REGULATORY INFORMATION DISTRIBUTION SYSTEM (RIDS)

SUBJECT: Responds to request for addl info re core shroud repair.
 Suppl 1 to GE-NE-B13-01739-04, "Suppl 1 to Nine Mile Unit 1
 Shroud" encl.

RE: Nine Mile Point Unit 1
Docket No. 50-220
DPR-63

Subject: *Response to Request for Additional Information Regarding the Nine Mile Point Unit 1 Core Shroud Repair (TAC No. M90102)*

LOWER SUPPORT

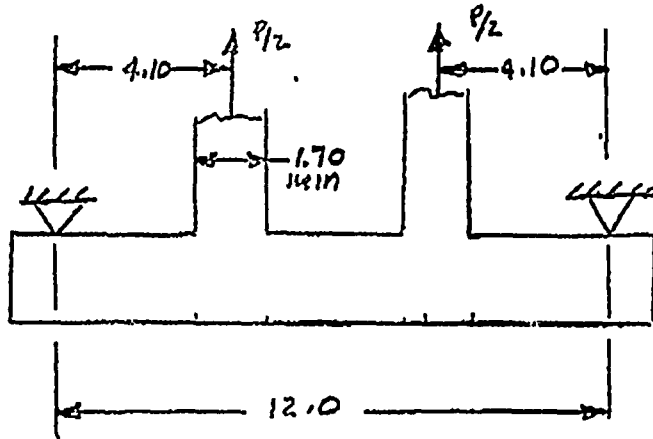
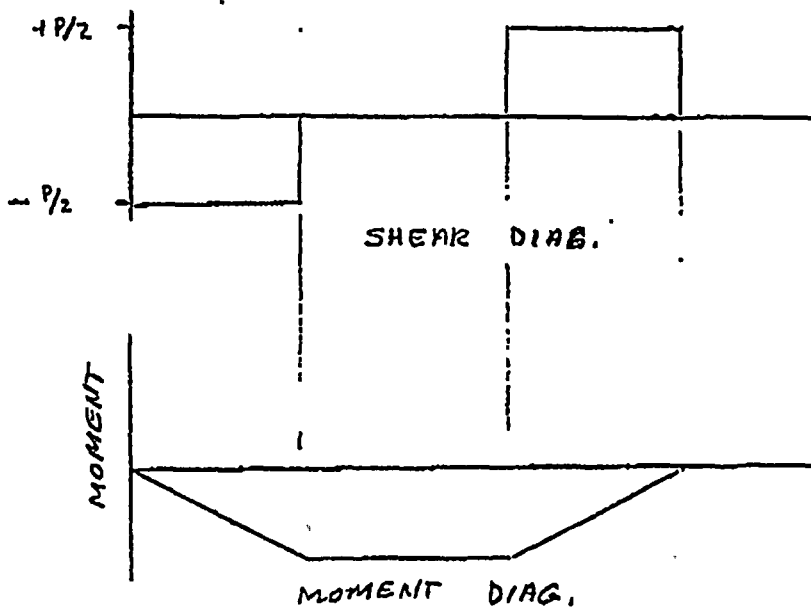
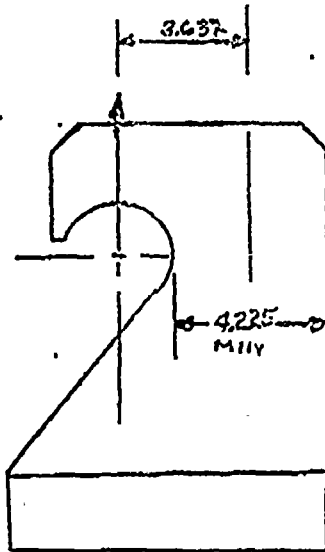
The summary of the hardware stresses provided with the repair hardware analysis, General Electric (GE) Report No. GE-NE-B13-01739-04, indicates that the stresses in the toggle and lower support are at or near the allowable values for the steamline break and design-basis earthquake (DBE) events. Provide the details of these calculations to demonstrate that the bending stresses in the toggle due to postulated failures of welds H₇ and H₈ have been considered in the evaluations.

The details of the lower support (Drawing 112D6585) stress calculations are attached (Attachment 2). The analysis of the lower support includes both tensile and bending stresses and is found acceptable.

Bending Stress = $\frac{6M}{bh^2} = \frac{6(P)(4.10)}{(7.98\text{in})(2.22\text{in})^2} = 0.3127 P$

Shear Stress = $\frac{P}{2A} = \frac{P}{2(7.98)(2.22)} = 0.0282 P$

EVENT	TIE ROD LOAD (P), LB	STRESS, PSI BENDING / SHEAR	ALLOWABLE BENDING / SHEAR
Normal	79,670	24,912 / 2246	71,250 (1.55m) / 28,500 (0.65m)
THERMAL UPSET	188,638	58,986 / 5319 $\times 10,638$	142,500 (3.5m) / 142,500 (3.5m)
SEISMIC UPSET	162,076	50,681 / 4570	71,250 (1.55m) / 28,500 (0.65m)
EMERGENCY	216,520	67,705 / 6106	106,806 (2.255m) / 42,750 (1.5x.65m)
FAULTED	311,710	97,471 / 8800	142,500 (3.5m) / 57,000 (2x.65m)

$$\sigma_B = \frac{6M}{bh^2} = \frac{6(P/2)(3.637)}{(1.68)(4.225)^2}$$

$$\sigma_B = 0.364P$$

$$\sigma_P = \frac{P}{2A} = \frac{P}{2(1.68)(4.225)} = 0.0704P$$

<u>EVENT</u>	<u>TIE ROD LOAD</u>	<u>$\sigma_P + \sigma_B$</u>	<u>ALLOWABLE</u>
Normal	79,670	34,617	71,250 (1.5Sm)
THERMAL UPSET	188,670	81,966	142,500 (3Sm)
SEISMIC UPSET	162,076	70,412	71,250 (1.5Sm)
Emergency	216,520	94,065	106,875 (2.25Sm)
Faulted	311,717	135,423	142,500 (3Sm)
